TAMPA ELECTRIC

May 10, 2001

**Re: Polk Power Station Unit 1
Syngas Fired Combustion Turbine NO_x BACT Determination**

Figure 1

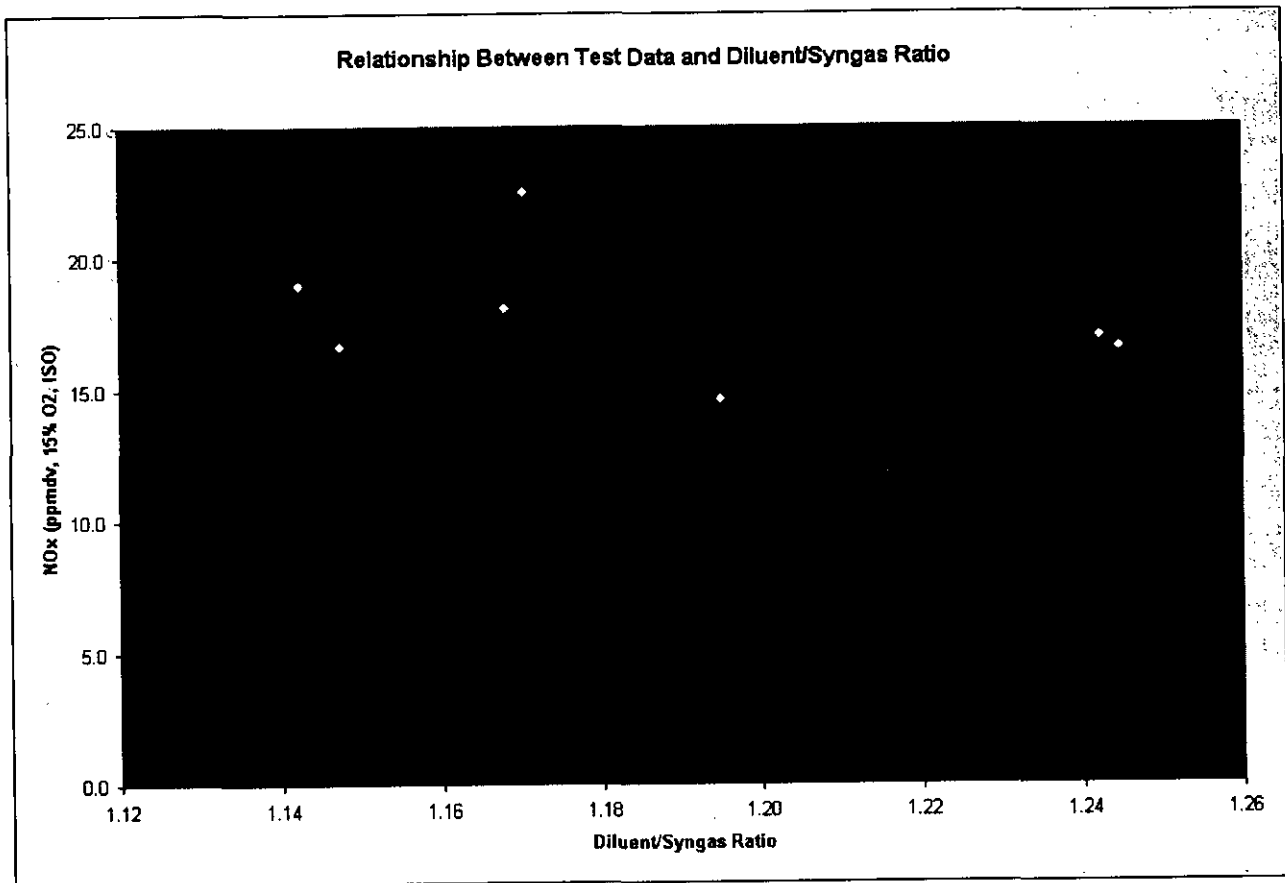
FDEP Comment 2

Please provide the average nitrogen diluent flow delivered to the CT during each of the seven NO_x BACT tests identified on page 4-1 of the submitted BACT analysis.

Test Date	Average Nitrogen Diluent Flow (lb/sec)	Average Syngas flow rate (lb/sec)	Average Nitrogen Diluent/Syngas Ratio	Average NOx Emissions Result (ppmvd, 15% O ₂ , ISO)
October 14, 1999	118.0	102.8	1.1	16.7
December 7, 1999	124.1	103.8	1.2	14.6
February 7, 2000	117.3	102.7	1.1	19.0
April 17, 2000	126.8	102.1	1.2	17.0
June 14, 2000	118.0	101.0	1.2	18.1
August 15, 2000	124.7	100.2	1.2	16.6
October 17, 2000	116.6	99.7	1.2	22.5

These data, presented graphically in the enclosed Figure 1, show no strong correlation between diluent/syngas flow rate and NO_x emissions rate. A linear regression analysis demonstrated a large error in fitting the data, with a regression coefficient of 0.14 thus, it may be concluded that factors other than the diluent/syngas flow ratio considerably affect the emissions performance of the combustion turbine.
